Lot 11 - Duncans Creek
 105 Beacon Hill Road
 Lillington, NC 27546

**The Holly - LH
 'CRAFTSMAN' ELEVATION**

Redlines complete 24-Feb-24

Cover Sheet 'Craftsman'

SCALE:
1/8" = 1'-0"
SHEET
2.1.1a

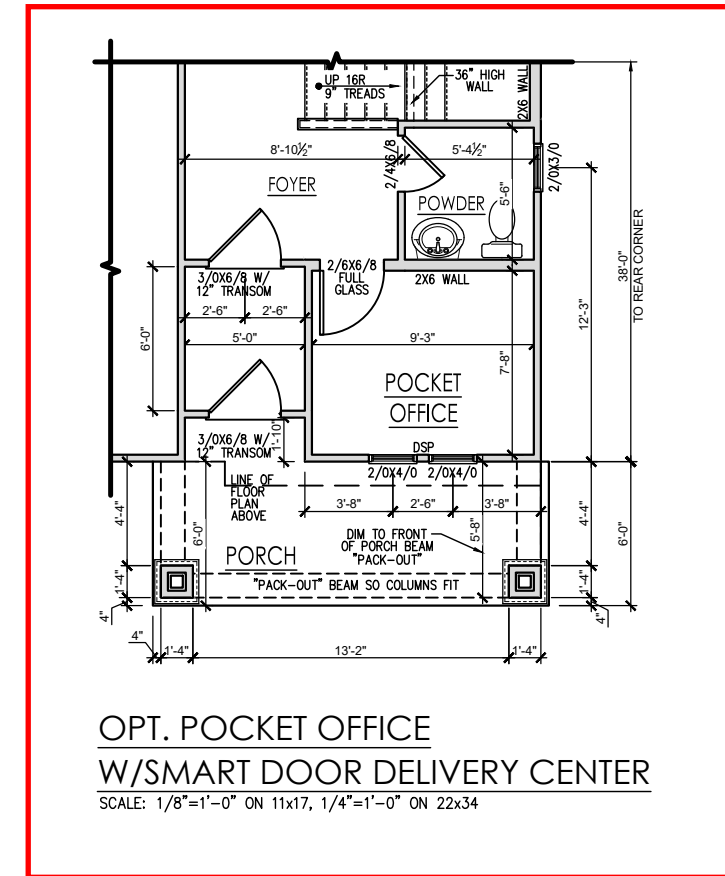
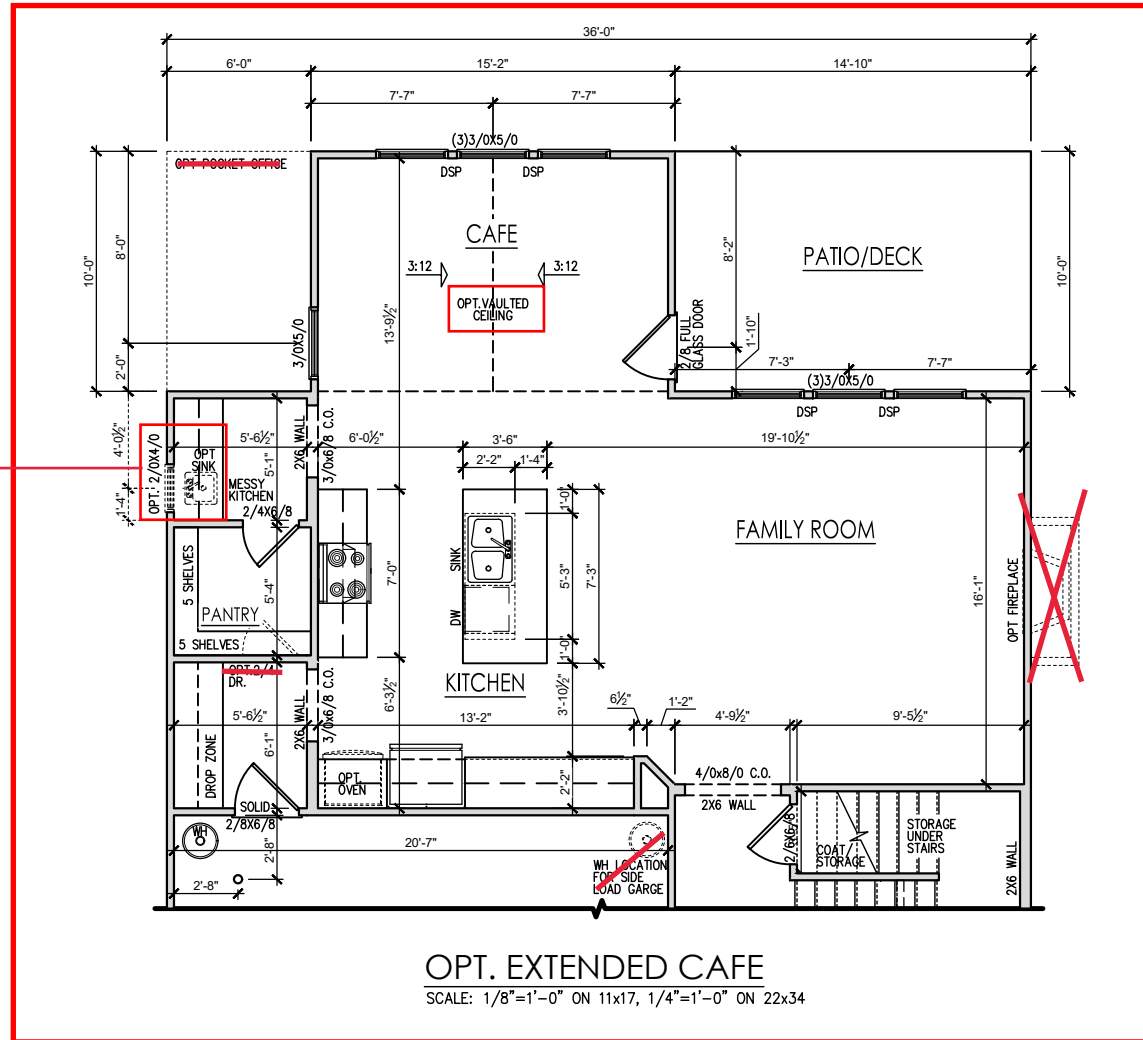
Adding Sink and Window at Messy Kitchen ←

Second Floor Plan 'Craftsman'

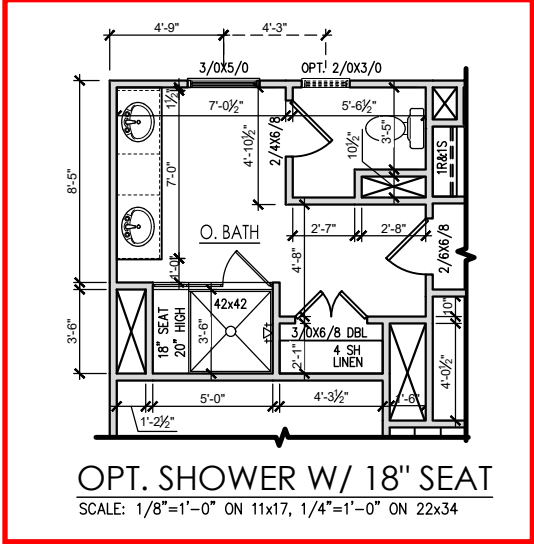
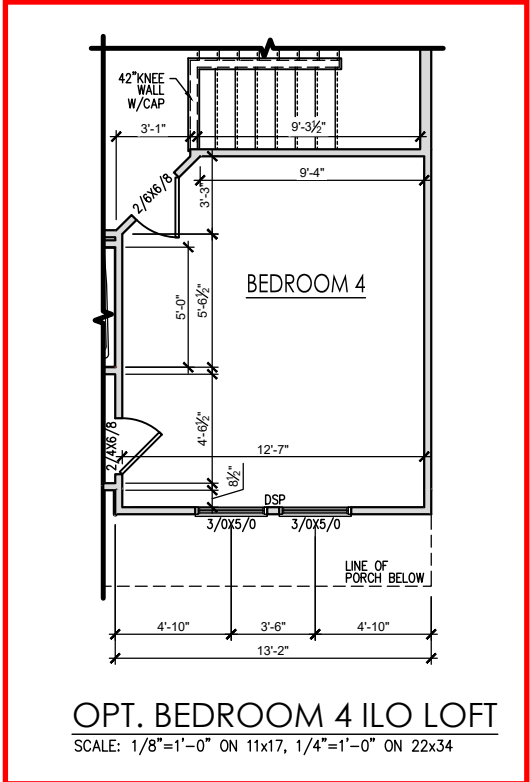
Adding Opt 2/0x3/0 Window

Adding Opt Door to Laundry
